Agenda
Village of Arlington Heights
Zoning Board of Appeals
Buechner Room, 1st Floor
33 S. Arlington Heights Rd.
December 13, 2021
7:00 PM

**Zoning Board of Appeals
12/13/2021**

Prepared By: Derek Mach, Planner
Hearing Date: December 13, 2021
Date Prepared: November 3, 2021
Project Title: John Residence
Address: 2315 N. Arlington Heights Rd.

SHEET TITLE
SITEPLAN

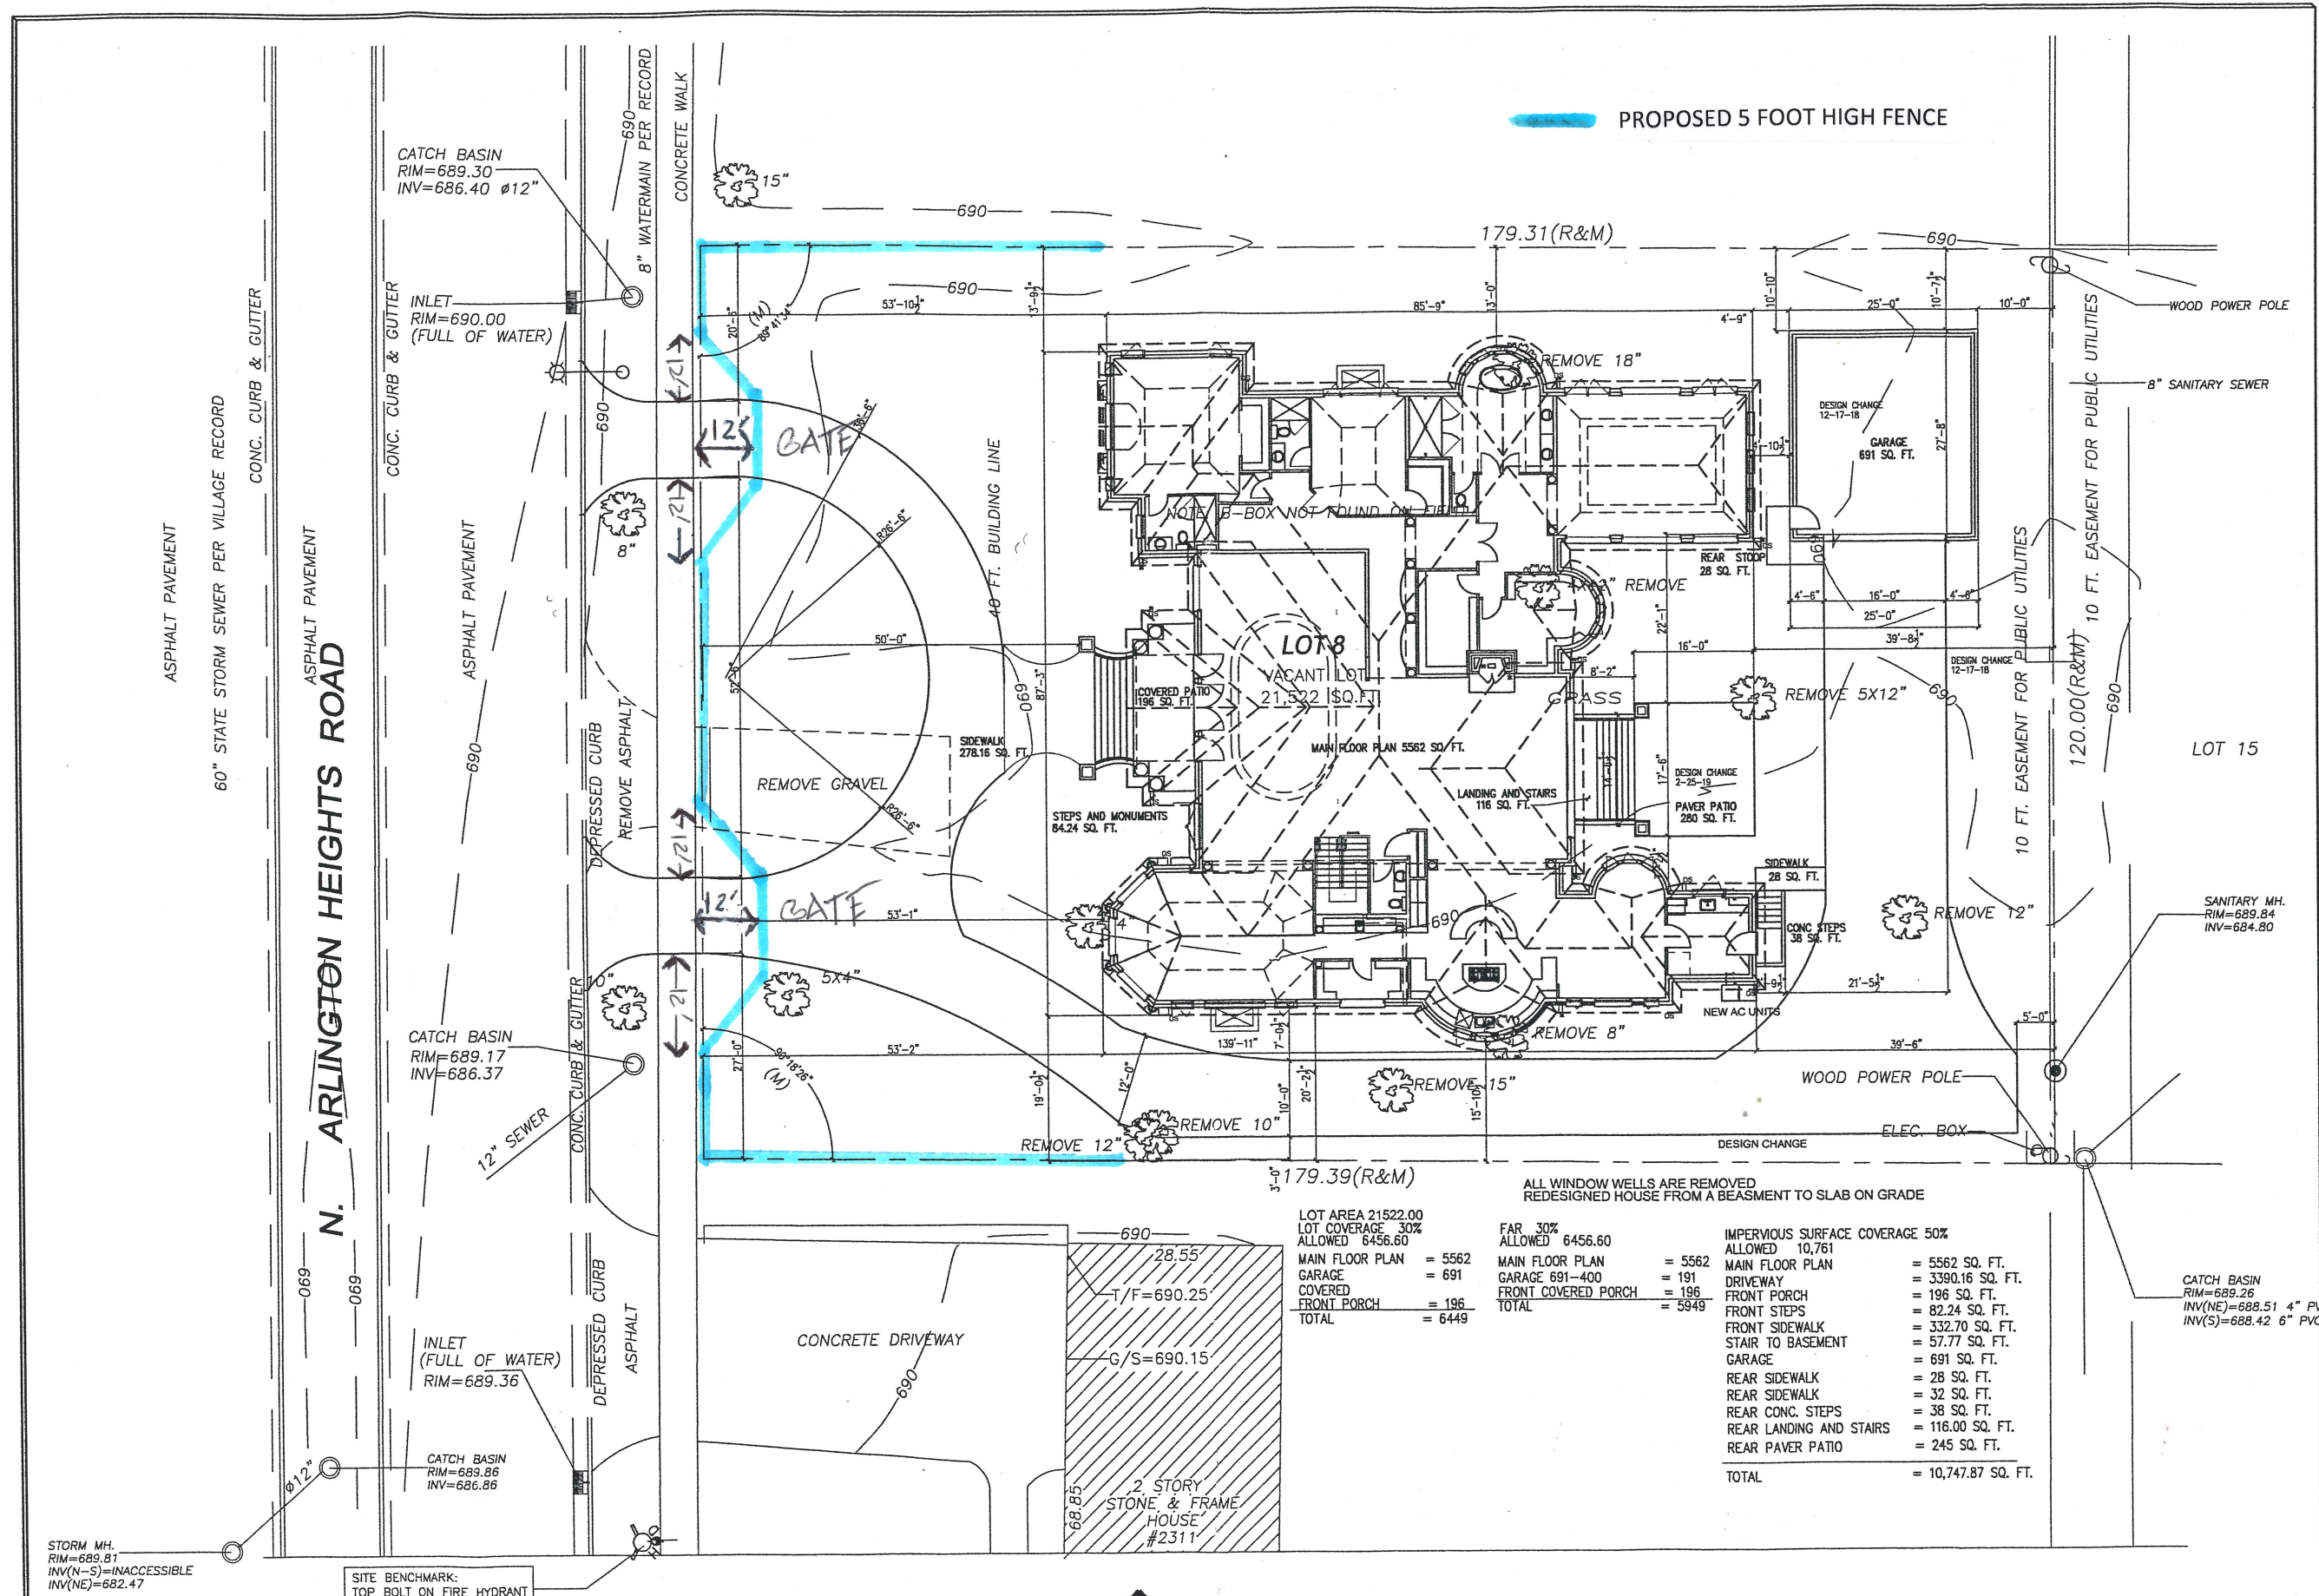
The Engineering Division is NOT IN FAVOR to the proposed variance request for allowing a 5-foot tall fence where code allows a 3-foot tall fence. The location must comply with the twelve-foot vision triangle from the right-of-way line. In addition, a standard vehicle is 15-16ft long and the space from the roadway to the gate would not provide a proper queuing area for a vehicle to wait while the gate opens. This would leave a vehicle partially on Arlington Heights Rd and has the potential to cause accidents.

PLAN THAT ADDRESSES SIGHTLINE AND QUEUING CONCERNS

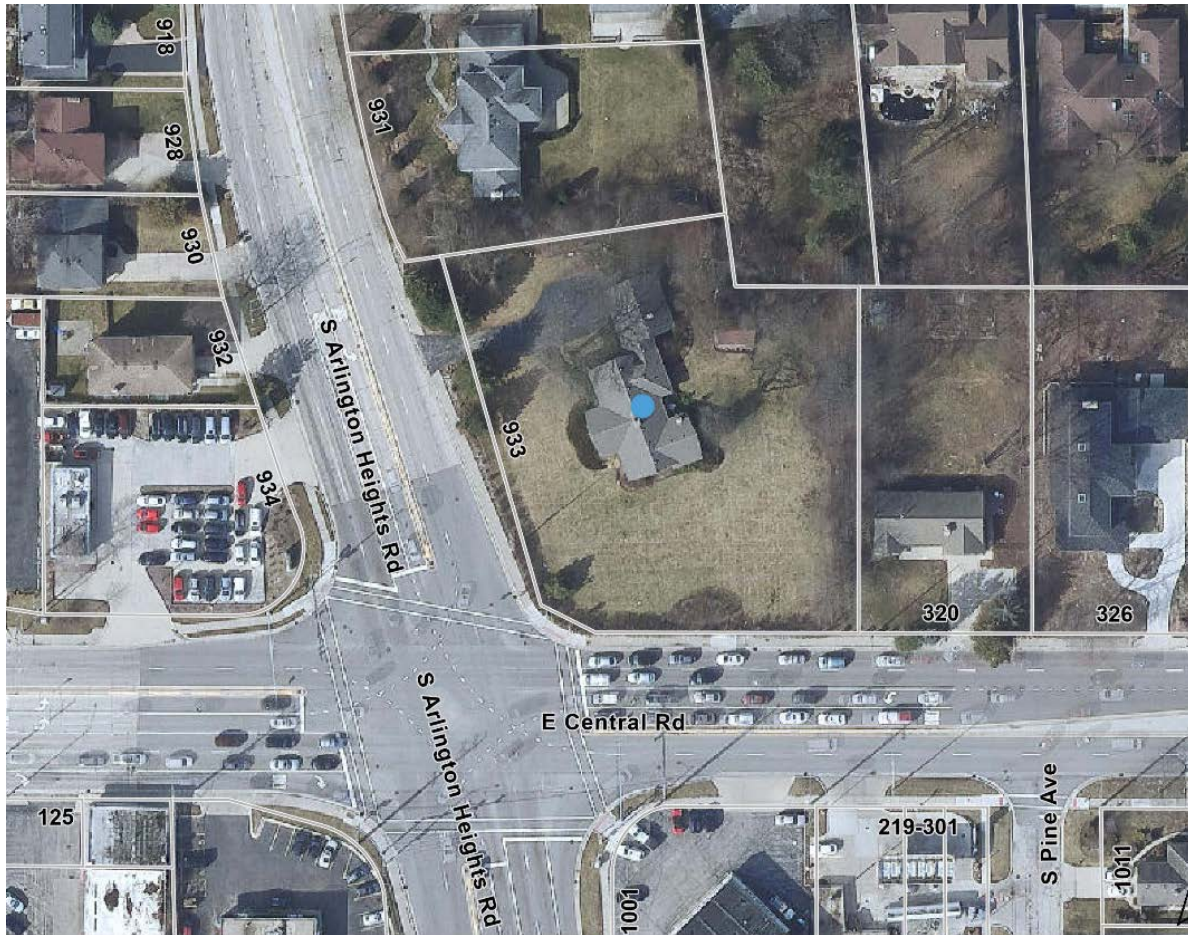
Staff has concerns with the proposed fence and the impact it will create at this corner; therefore, it is recommended that the petitioner comply with code. If the Zoning Board supports the request, it is recommended that dense landscaping be required on the street side of the fence in order to soften the appearance. In addition, the location must comply with the twelve-foot vision triangle at the corner of Central Road and Arlington Heights Road as well as adjacent to the driveway. The petitioner is requesting the following variation:

The Engineering Division has NO OBJECTION to the variance request for Location of Fences and Location of Fences- Front Yard variance request. However, the location must comply with the twelve-foot vision triangle at the corner of the corner of Central Road and Arlington Heights Rd and this must be shown on plan at time of permitting. In addition, the gate/fence should be set back at least 25' from the street to provide a space for a car to pull in and not sit on Arlington Heights Rd.
